The Town of Hilton Head Island
Design Review Board Regular Meeting
Tuesday, August 13, 2019 – 1:15 p.m.
Benjamin M. Racusin Council Chambers
AGENDA

Town of Hilton Head Island
Design Review Board
Tuesday, July 30, 2019 at 1:15 p.m.
Benjamin M. Racusin Council Chambers

DESIGN TEAM/DRB COMMENT SHEET

DESIGN TEAM/DRB COMMENT SHEET

DRAWING NUMBER
L503

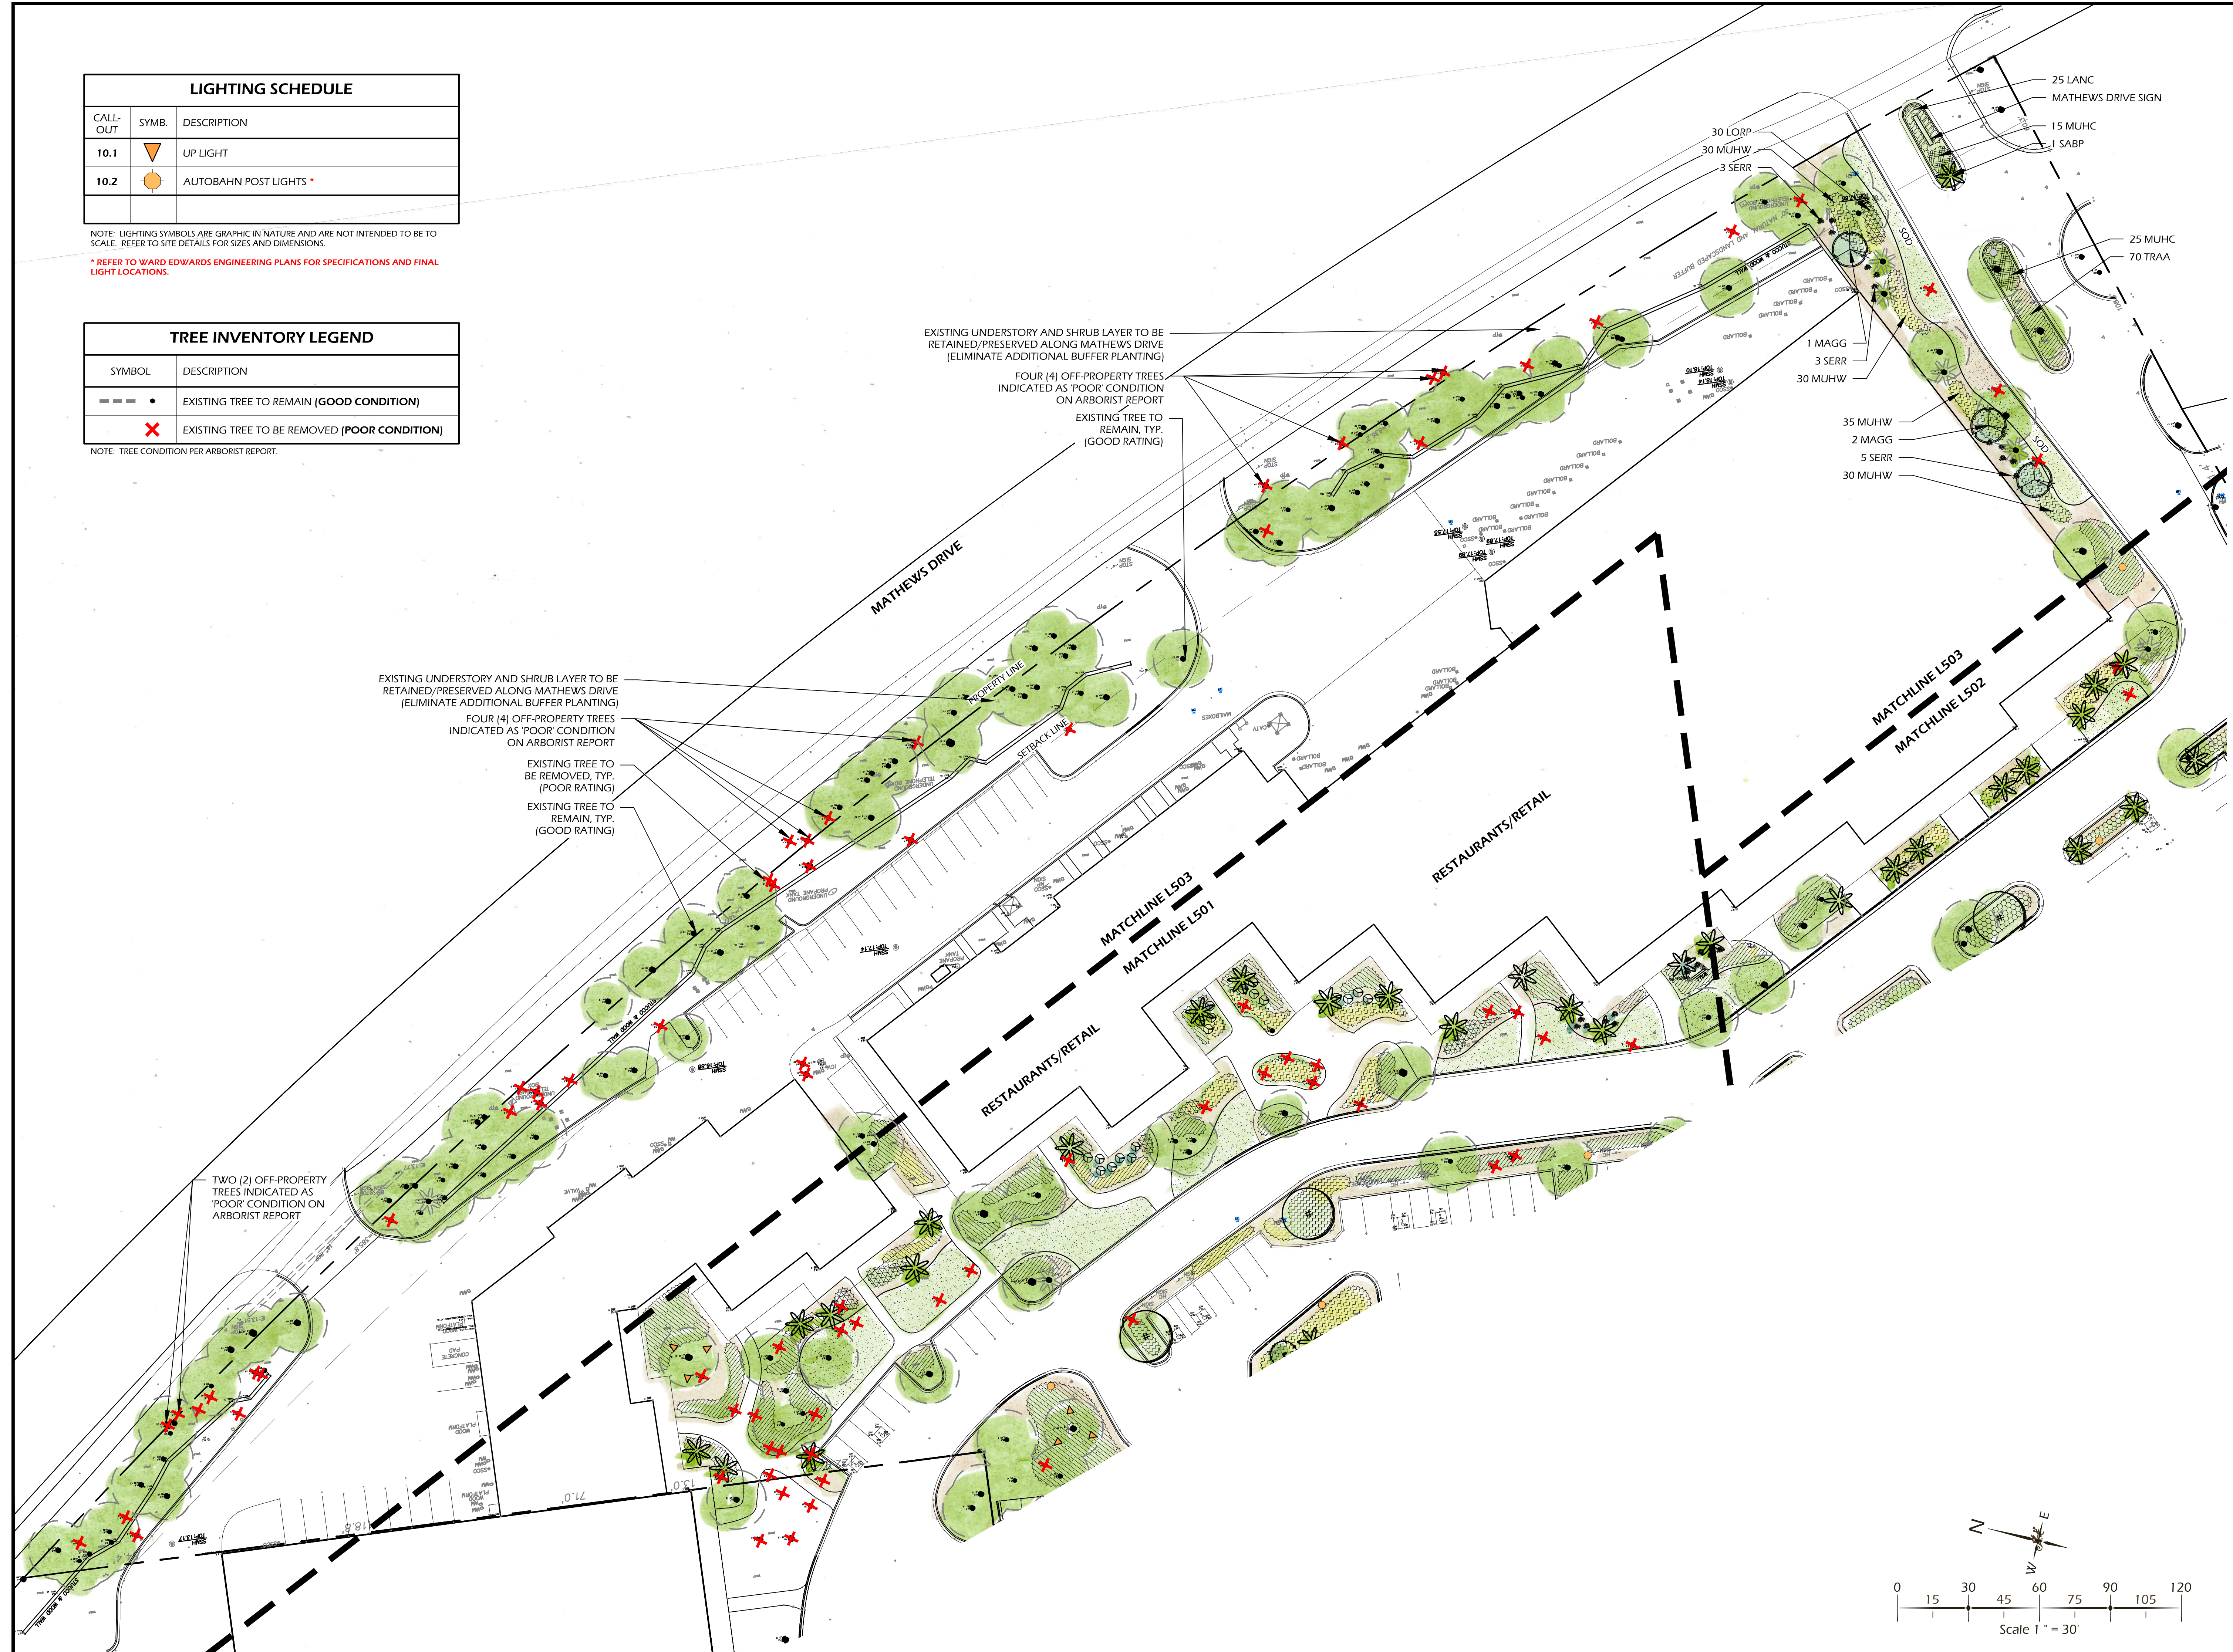
DESIGN GUIDE/LMO CRITERIA	Complies Yes	No	Not Applicable	Comments or Conditions
Preserves a variety of existing native trees and shrubs	<input checked="" type="checkbox"/>	<input checked="" type="checkbox"/>	<input type="checkbox"/>	Provide a fertilization program for significant trees on this site.
Location of existing trees and new trees provides street buffers, mitigation for parking lots, and an architectural complement that visually mitigates between parking lots and building(s)	<input type="checkbox"/>	<input checked="" type="checkbox"/>	<input type="checkbox"/>	At a minimum the landscape plan should include the required mitigation trees. Additional tree preservation and or mitigation may be required by the DRB. <i>Based on Staff’s understanding of the note in red on sheet L520, Staff recommends that the DRb not approve the landscape plan until the mitigation trees are shown on that plan. The applicant should schedule a meeting with the TOHH Urban Designer and Natural Resource Planner to identify and mark trees to be removed in the field so that mitigation requirements can be determined.</i>

Shrubs are selected to complement the natural setting, provide visual interest and screen less desirable elements of the project	<input type="checkbox"/>	<input checked="" type="checkbox"/>	<input type="checkbox"/>	No understory planting is proposed along Mathews Drive.
Large grassed lawn areas encompassing a major portion of the site are avoided	<input checked="" type="checkbox"/>	<input checked="" type="checkbox"/>	<input type="checkbox"/>	The use of lawn along Hwy 278 should be reduced.

DESIGN GUIDE/LMO CRITERIA	Complies Yes	No	Not Applicable	Comments or Conditions
An effort has been made to preserve existing trees and under story plants	<input checked="" type="checkbox"/>	<input checked="" type="checkbox"/>	<input type="checkbox"/>	Trees in fair condition should be preserved with a preservation program that may include fertilization, mycor treatment and / or root stimulation.

OVERALL FLOOR PLAN

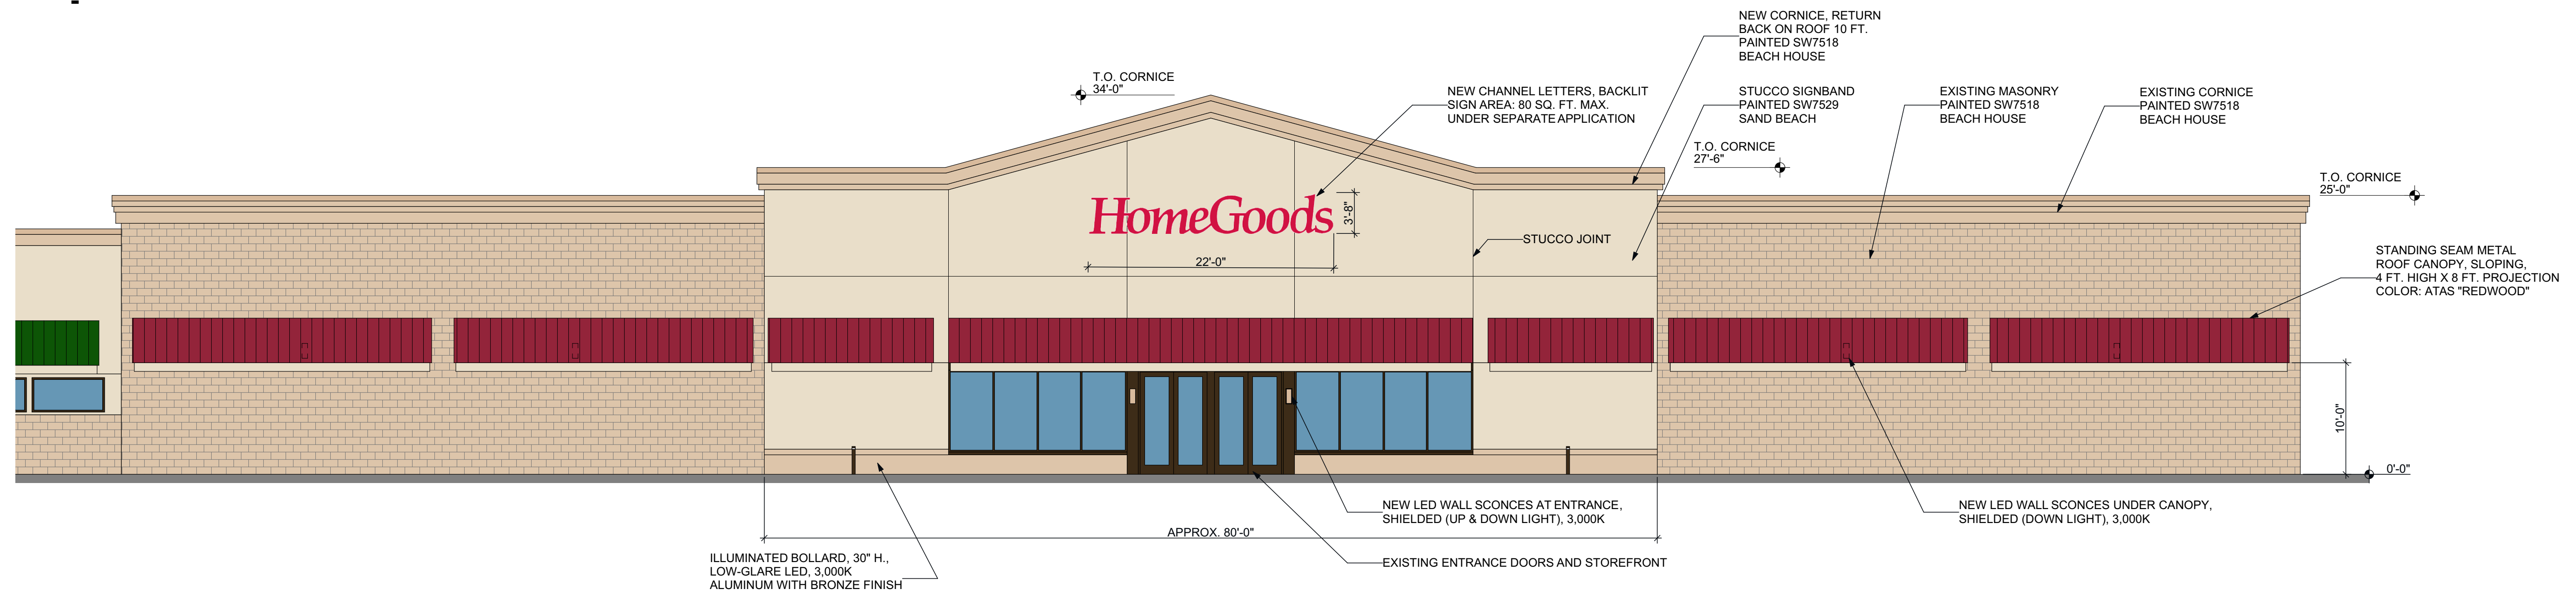
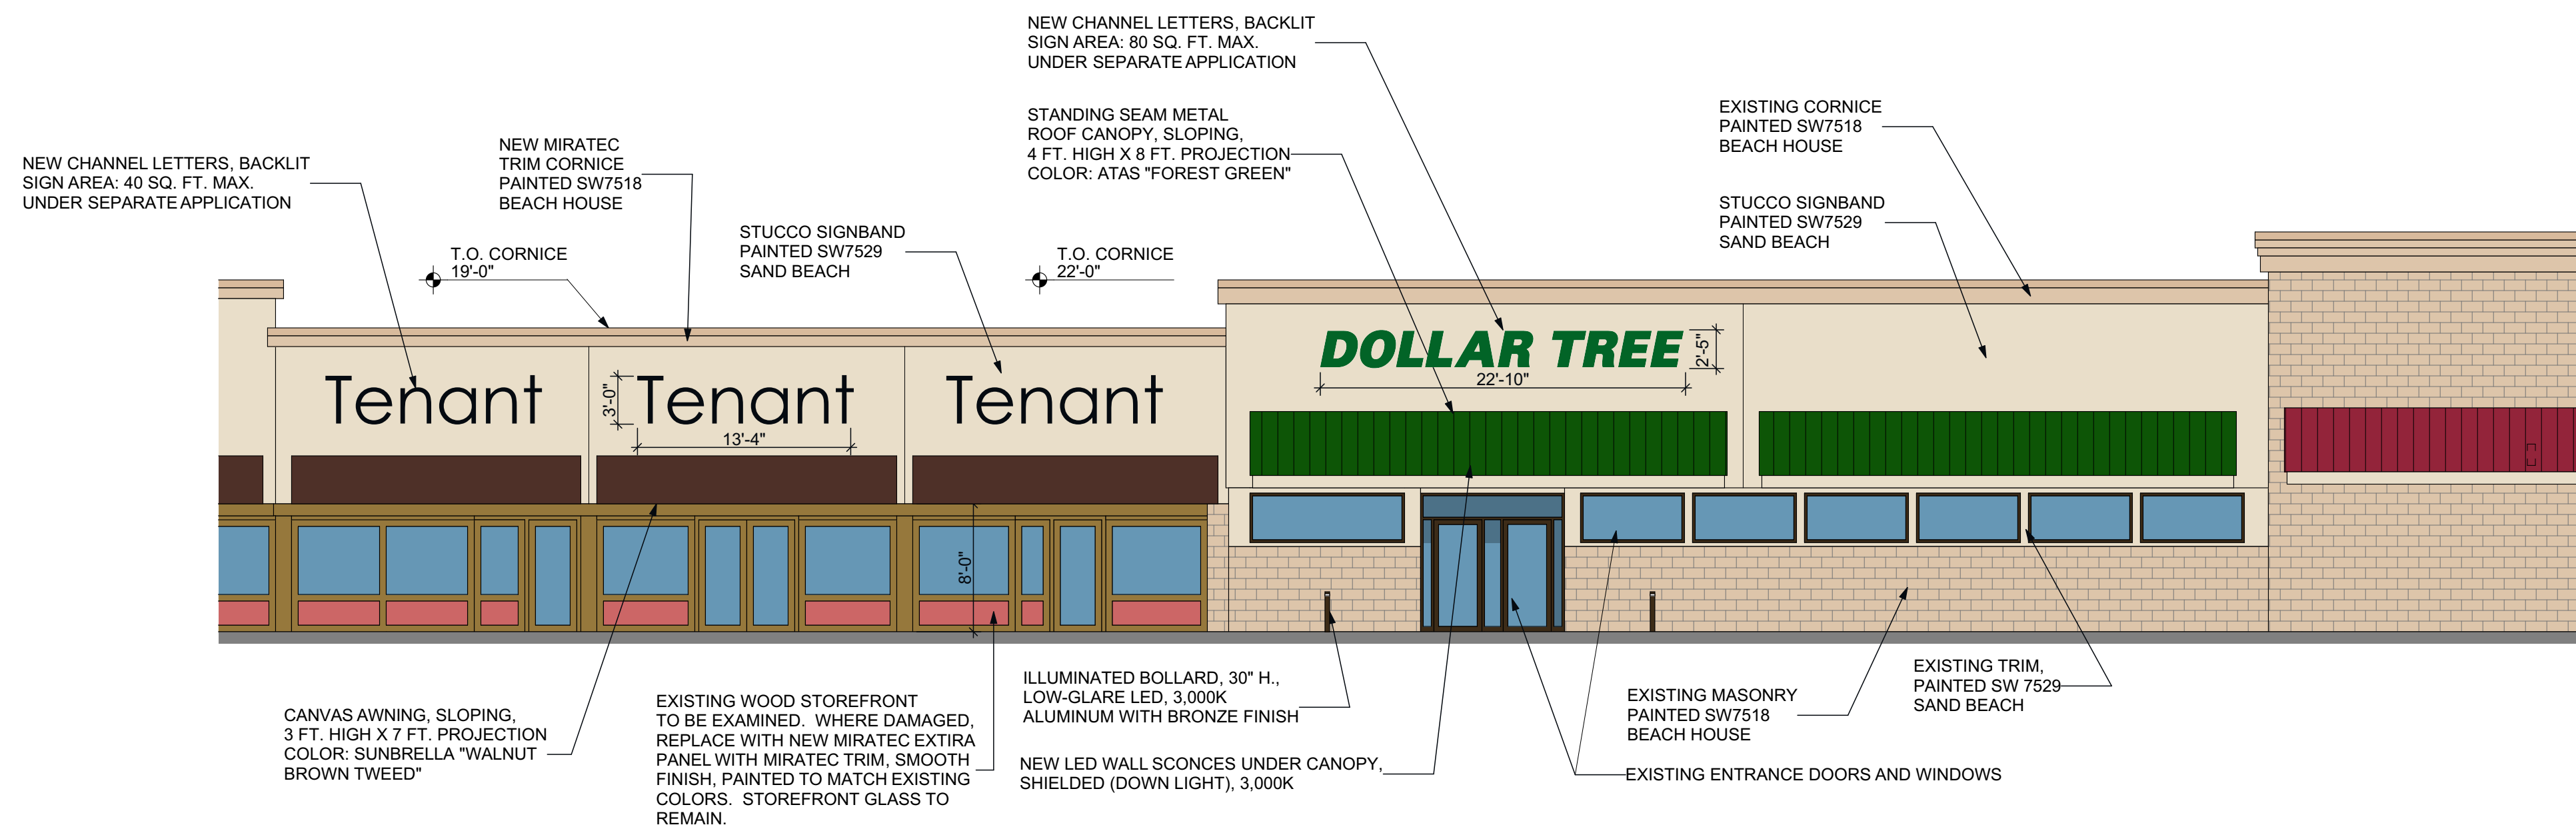
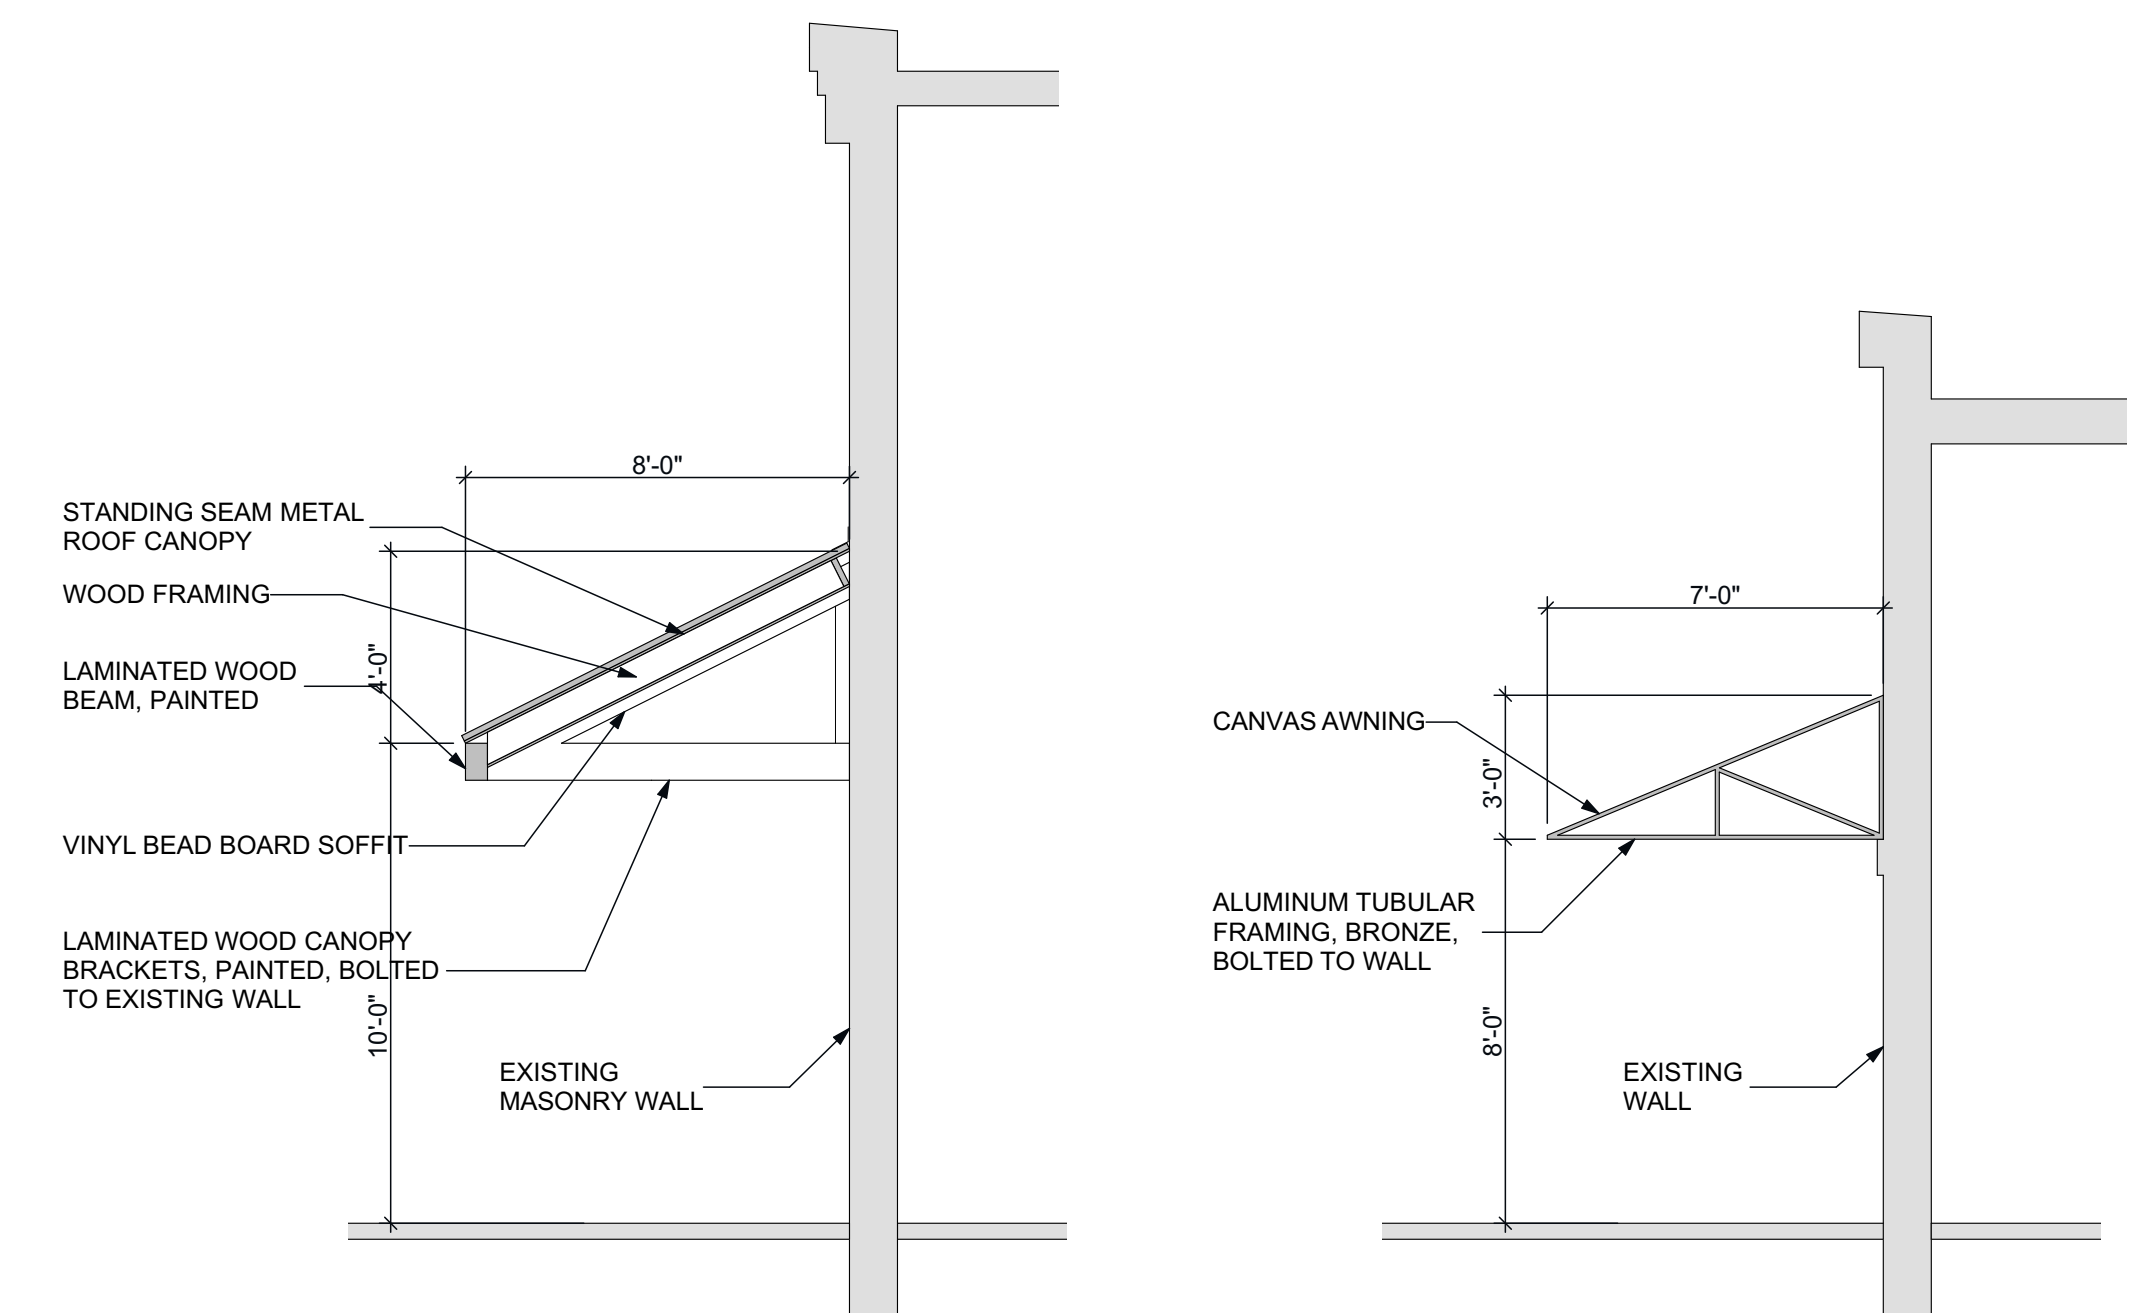
<i>ARCHITECTURAL DESIGN</i>				
DESIGN GUIDE/LMO CRITERIA	Complies Yes	No	Not Applicable	Comments or Conditions
Promotes pedestrian scale and circulation	<input type="checkbox"/>	<input checked="" type="checkbox"/>	<input type="checkbox"/>	The removal of the covered pedestrian walk, specifically, at Home Goods and Dollar Tree takes this center in the opposite direction, add architectural detail that provide a sense of pedestrian scale to these areas. The existing covered pedestrian walk has columns and is deep enough to mitigate the blank wall

that is behind it. The proposed canopy at Home Goods and Dollar Tree is not deep enough and it's roof large enough to soften the wall behind it. Staff suggest that columns be added to the canopy and or the addition of other architectural detail to the back wall. How will the blank walls be treated where the building steps back, i.e., between space 10 and 9 and the Dollar Tree and space 3A.
Design is unobtrusive and set into the natural environment	<input type="checkbox"/>	<input checked="" type="checkbox"/>	<input type="checkbox"/>	The proposed awnings at Home Goods and Dollar Tree are not nature blending colors and do not coordinate with the balance of the center. A physical color board will need to be submitted to adequately review the proposed materials, colors and finishes. The color of the metal roof canopies should be consistent and relate to the building color scheme and not the current tenants brand colors.

Utilizes natural materials and colors	<input checked="" type="checkbox"/>	<input checked="" type="checkbox"/>	<input type="checkbox"/>	The proposed stacked stone façade is not a material native to the island and is not in keeping with "Island Character".
Avoids monotonous planes or unrelieved repetition	<input type="checkbox"/>	<input checked="" type="checkbox"/>	<input type="checkbox"/>	The repetition beyond Dollar Tree could be broken up with color (at a minimum), additional treatment of the "tower" elements or variation of / in the awning system.
Has a strong roof form with enough variety to provide visual interest	<input type="checkbox"/>	<input checked="" type="checkbox"/>	<input type="checkbox"/>	The strong roof form has been eliminated at Home Goods.
Overhangs are sufficient for the façade height.	<input checked="" type="checkbox"/>	<input checked="" type="checkbox"/>	<input type="checkbox"/>	Provide a sections of the new canvas awnings proposed.
